February 16, 2021

Subject: LIHI Recertification for the Medway Project (FERC No. 2666; LIHI Certificate No. 65), Orono Project (FERC No. 2710; LIHI Certificate No. 66), and Stillwater Project (FERC No. 2712; LIHI Certificate No. 67); Response to Maine Department of Marine Resources Comments

Black Bear Hydro Partners, LLC (Black Bear) herein files responses to comments provided by the Maine Department of Marine Resources (MDMR) for the Medway, Orono, and Stillwater Project LIHI recertification applications. The Medway Project (FERC No. 2666) is licensed to Black Bear, while the Orono Project (FERC No. 2710) and the Stillwater Project (FERC No. 2712) are licensed to Black Bear; Black Bear SO, LLC; and Black Bear Development Holdings, LLC, who are affiliates of Brookfield Renewable (Brookfield).

Figure 4-1: Total flow and water temperature as recorded at Medway for the period October 15 to November 15, 2020.

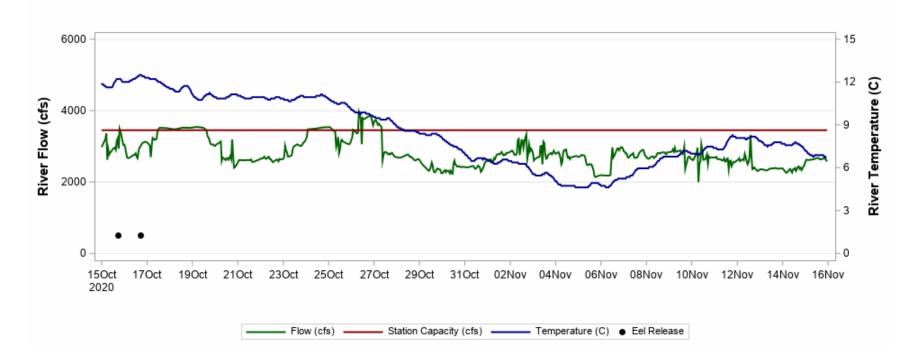
- 1) Please include a line showing the Medway station hydraulic capacity in Figure 4-1.
- 2) Please add the sample size to each table.
- Please include the reach-specific survival estimate from station M8 to M9 in Table 4-9 and Table 4-11.
- 4) Please add clarification in the descriptions for Table 4-9 and 4-11. The report states that Station M1 was not functioning from 1700 on 10/15 to 1000 on 10.16 and that Stations M2, M3, or M4 were used as surrogates for "arrival time." However, the reaches in Table 4-9 and 4-11 only list Station M1.

Question 1: Please include a line showing the Medway station hydraulic capacity in Figure 4-1.

Response 1: The Medway powerhouse contains a total of five vertical Francis turbines, each with a capacity discharge of 690 cfs. A reference line for the station capacity (3,450 cfs) has been added to Figure 4-1.
